Girardin Minibus recall  
campaign:  
05-009-CRA

Flat bar installation on each side of the seat where the child seat anchorage is bolted (to increase the strength of the seat back)

NHTSA  
recall #  
05V-141

Transport  
Canada  
recall #  
05-101

Picture 2: Aisle side flat bar N/P : 51DZZ001

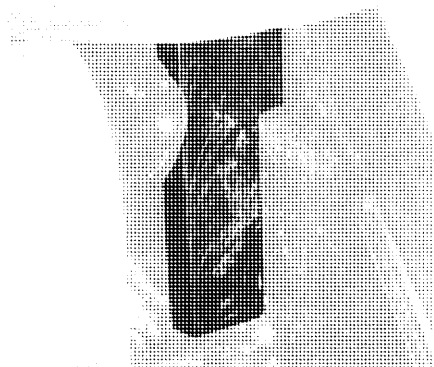
2. Remove the bolts from the child seat anchorage. Be careful not to move the anchorage.
3. Pull up the bottom of the seat back cover & put the flat bars in place as shown on the pictures below. Take note that there are two different flat bars. One is designed to be installed on the wall side and the other on the aisle side.

Picture 4: Marker inside the hole where the fastening bolt goes (at the back of the seat)

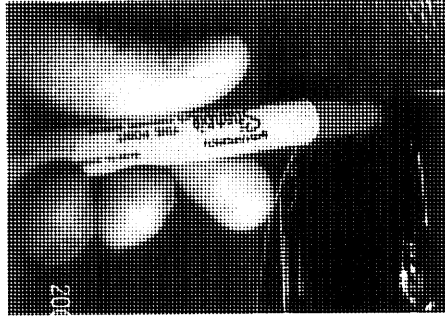
4. Mark the position of the fastening bolts on the flat bars with a marker or with a centre punch.

5. Remove the flat bar and drill a 3/8" hole where you have made a mark. Do not drill the flat bars without marking them on the seat where they will be installed. The position of the holes may vary from one seat to another due to the manufacturing tolerance of the seats.
6. Fix the flat bars with 5/16"-18 NC x 2" long bolts P/N: 370-205167 and use the lock nuts 5/16" P/N G-5299 supplied. You will need one bolt & one lock nut per flat bar. Torque the bolts at 16 ft-lb (22 Nm).
7. Put the seat back cover as it was before and reinstall the seat bottom.
8. Repeat the above steps for all seats equipped with child seat anchorage.
